SUBJECT: Pilgrim Nuclear Power Station's Second Six-Month Status Report in Response to March 12, 2012 Commission Order Modifying Licenses with Regard to Reliable Spent Fuel Pool Instrumentation (Order Number EA-12-051)

Pilgrim Nuclear Power Station
Docket No. 50-293
License No. DPR-35

LETTER NUMBER 2.14.012

**PILGRIM NUCLEAR POWER STATION'S
SECOND SIX-MONTH STATUS REPORT IN RESPONSE
TO MARCH 12, 2012 COMMISSION ORDER MODIFYING
LICENSES WITH REGARD TO
RELIABLE SPENT FUEL POOL INSTRUMENTATION
(ORDER NUMBER EA-12-051)**

Figure 1: SFP Plan View

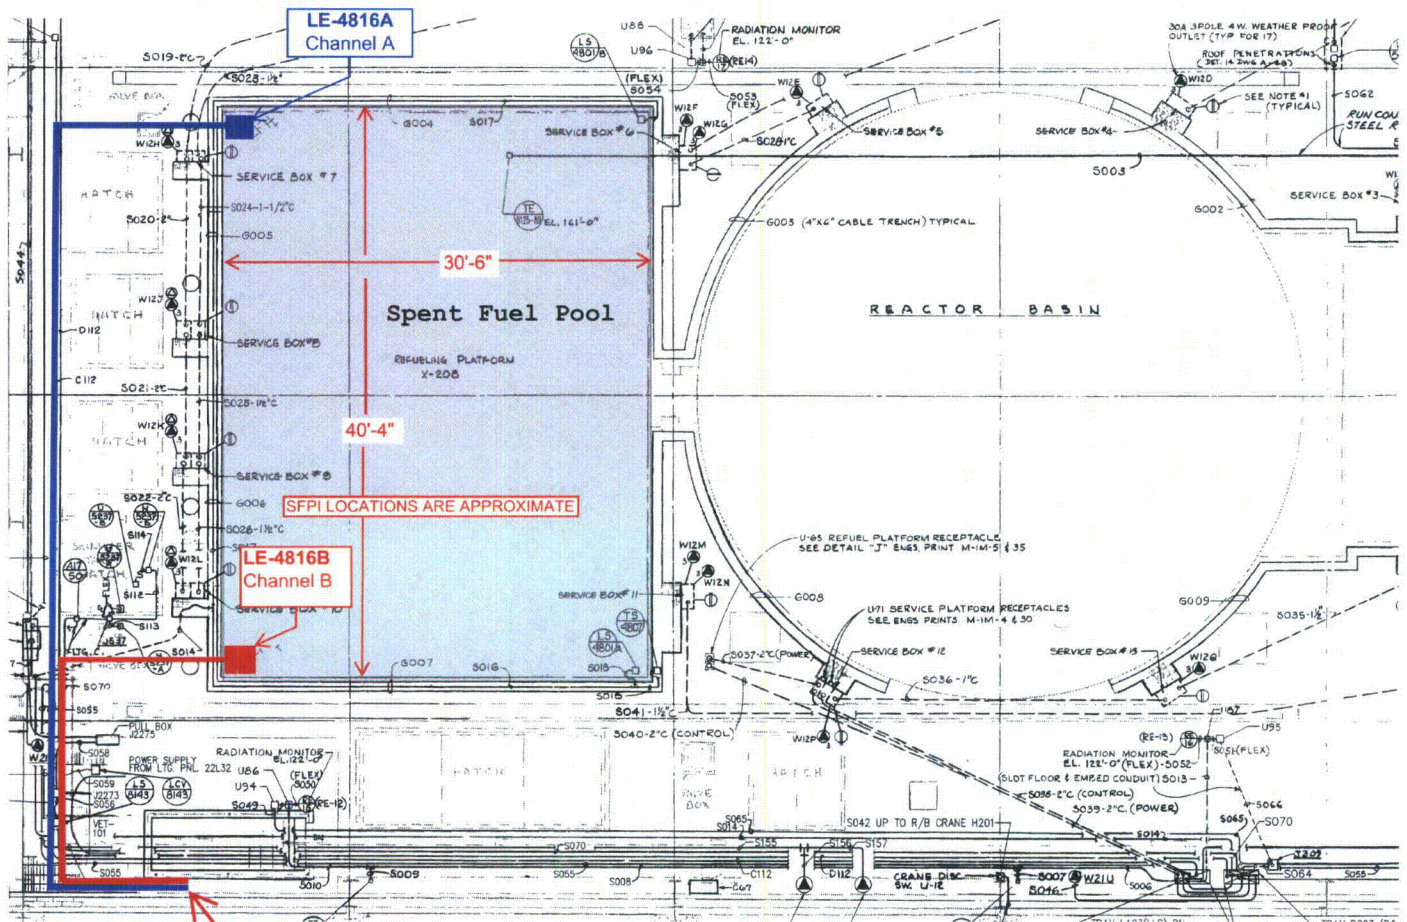
Please provide a clearly labeled sketch or marked-up plant drawing of the plan view of the SFP area, depicting the SFP inside dimensions, the planned locations/placement of the primary and back-up SFP level sensor, and the proposed routing of the cables that will extend from these sensors toward the location of the read-out/display device.

In Section 3.4 of the Interim Staff Evaluation (ISE), NRC staff stated that they have concerns with the proximity of the routing from the instrument probe to the instrument display location and whether this arrangement is in accordance with the guidance on channel separation, as described in NEI 12-02. The SFPI conduit is routed to exit the Refuel Floor, elevation 117 ft as soon as possible to minimize the possibility of physical damage to both loops from damage due to potential debris during a beyond design basis external event. The Channel A conduit will be installed on or very close to the floor at the west wall until it exits the refueling floor. The Channel B conduit will be installed at a higher elevation above the refueling floor in the southwest corner until it exits the refueling floor.

Figure 1 shows the approximate locations of the SFPI probes, the inside dimensions of the SFP, and the proposed cable routing.

Figure 2: SFPI Power Supply Diagram

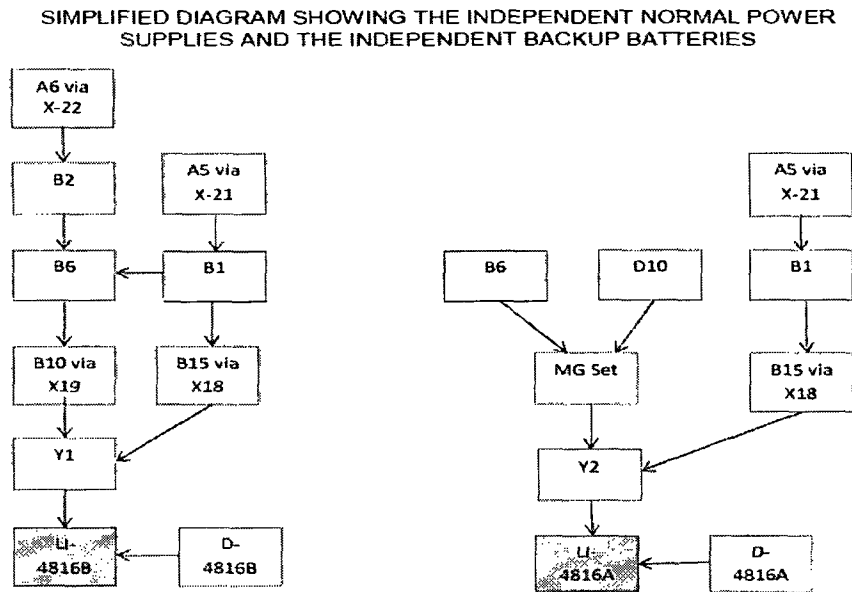
Please provide the NRC staff with the final configuration of the power supply source for each channel so that the staff may conclude that the two channels are independent from a power supply assignment perspective.

Channel A will normally be powered from Y2 Breaker 1. Panel Y2 can be energized from either of two sources. The normal or preferred supply is the Vital MG set. Normally the motor-generator (MG) set is driven by the 480V AC motor. Upon loss of power center B6 or in the event that the 480V feeder Breaker 52-606 trips, the MG is automatically maintained in rotation by the backup 250V DC motor. The alternate or emergency source consists of 480V power center Breaker 52-1514 with its associated transformer X18. B15 is powered from A5 via B1.

Channel B will normally be powered from Y1 Breaker 1. Panel Y1 can be energized from either of two sources. The normal or preferred source is via transformer X19 and 480V breaker 52-1015 on power center B10. B10 is powered from A5 via B1 and B6 or from A6 via B2 and B6. Should the normal supply fail, Panel Y1 is transferred to the alternate source which is via transformer X18 and 480V breaker 52-1514 on power center B15. B15 is powered from A5 via B1. Figure 2 shows a simplified diagram that demonstrates the independence of the power supplies.
